STANDARDS SHEET

DRAWN	R.J.S.	CLASSIFICATION	STANDARD
CHECKED		SEAT	
STRESSED	Itz. e.m.	STRAP- RESTRAINING	CSP-308
APPROVED

DRAWN	KROMKAMP	CLASSIFICATION	STANDARD
CHECKED	RK	STRAP - RETAINING	CSP 308 SHEET 2
STRESSED	WLB		
APPROVED	SCHWARTZ

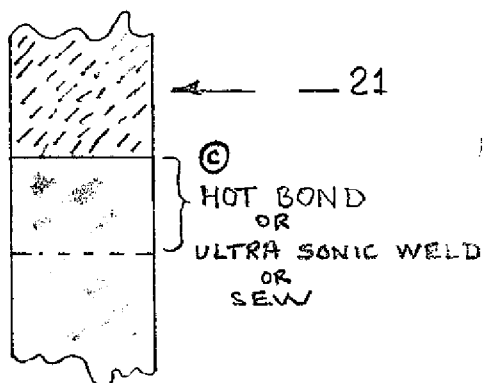
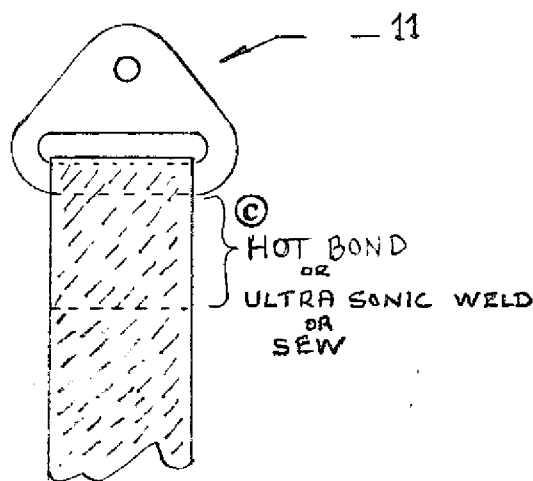
Note: Tensile shear strength of each ~~bonded~~ joint shall ~~exceed breaking~~
strength of material not be less than 40 lbs.

#1001 NAPPED LOOP WAS "1000"

#80 VELCRO HOOK WAS

#80 VELCRO HOOK WAS

3.50" HOOK WAS 3"

ULTRA SONIC & SEWING ADDED.

TENSILE SHEAR ADDED.

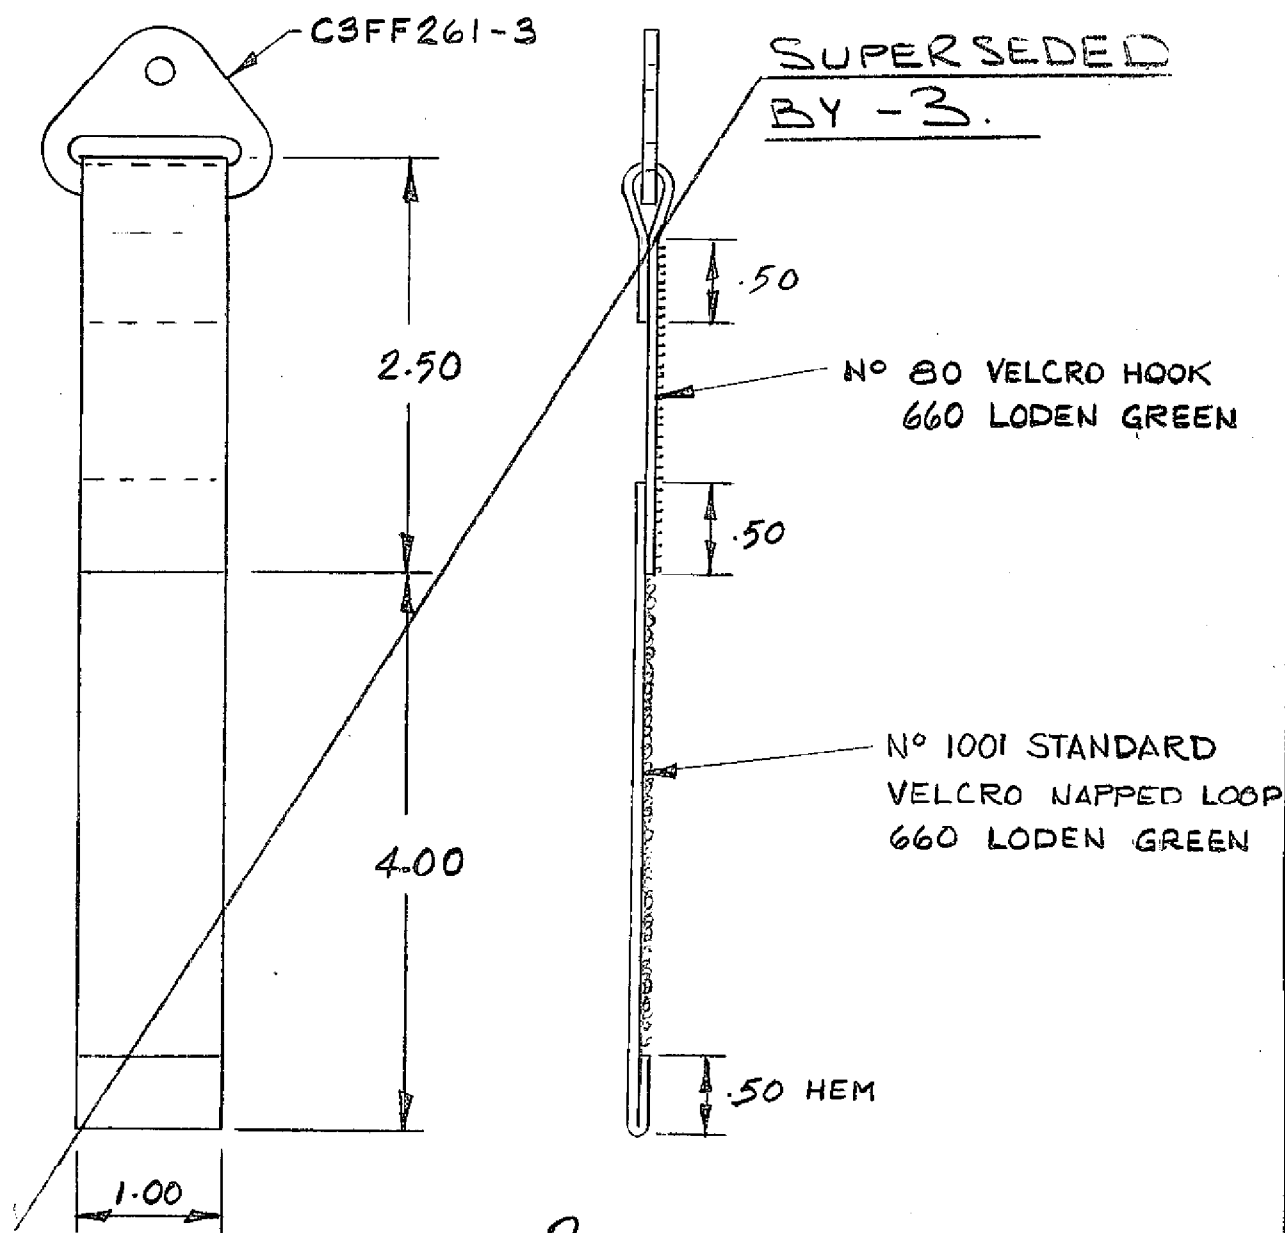
(A) - 2 SUPERSEDED BY -3
P LAM 6.12.79

SHEET 3

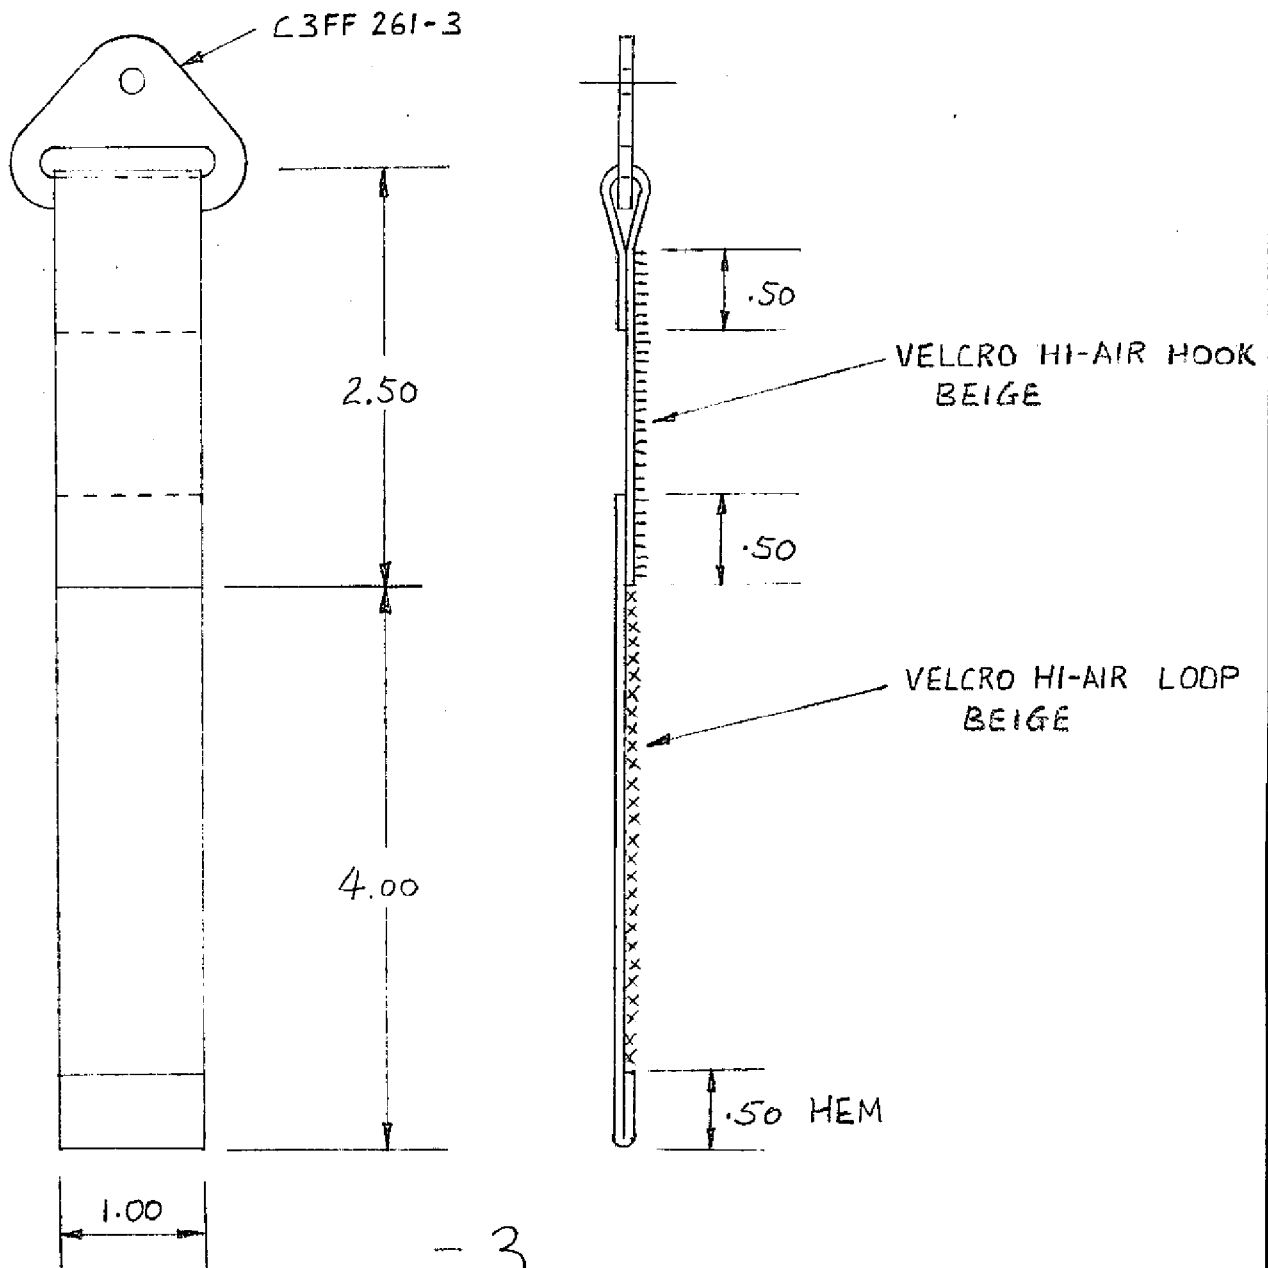
- (A) - ALL JOINTS TO BE HOT BONDED, OR ULTRA SONIC WELDED OR SEWN.
 - SHEAR STRENGTH OF EACH ~~BONDED~~ JOINT SHALL ~~EXCEED~~
 (A) ~~BREAKING STRENGTH OF MATERIAL~~. NOT BE LESS THAN
 40 LBS.

ULTRA SONIC & SEWING ADDED. RA
 TENSILE SHEAR ADDED. JB, 20 SEPT. 82

DRAWN	KRONKAMP	CLASSIFICATION	STANDARD
CHECKED	FLAM	STRAP - RETAINING	CSP 308
STRESSED	WILCO		
APPROVED	SCHATTNER

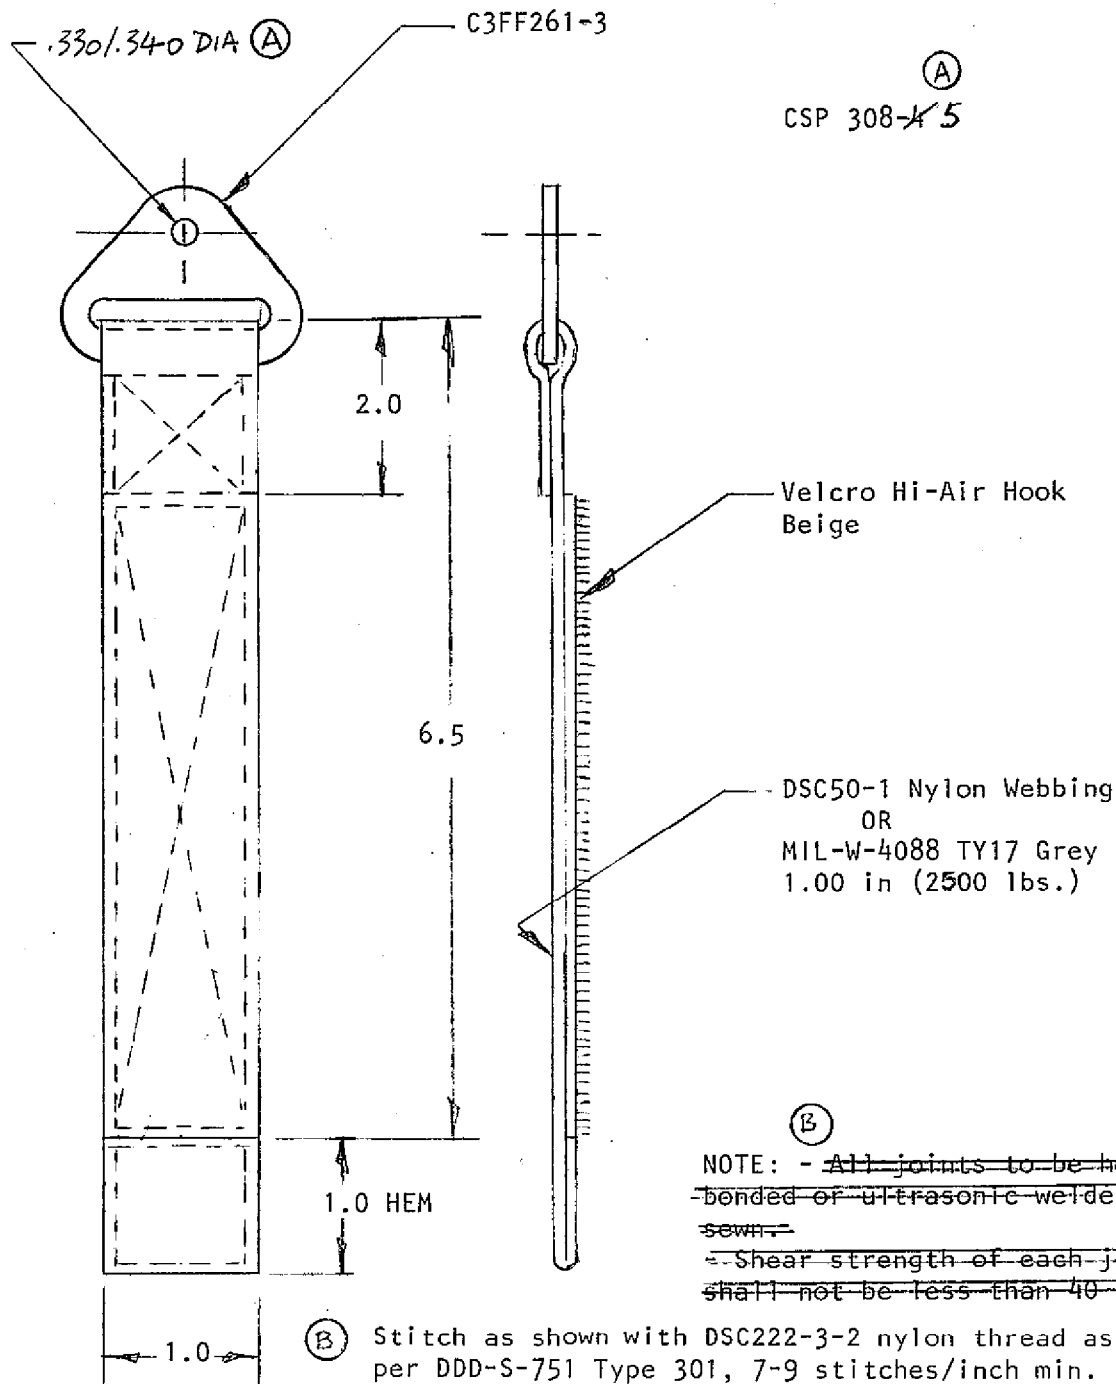
(A) .330/.340 DIA ADDED
WAS -4 NOW -5
REF EO 8411854
P. LAM 06.05.86

(B) NOTE REQMIT
CHANGED Y.
20 SEPT. 96
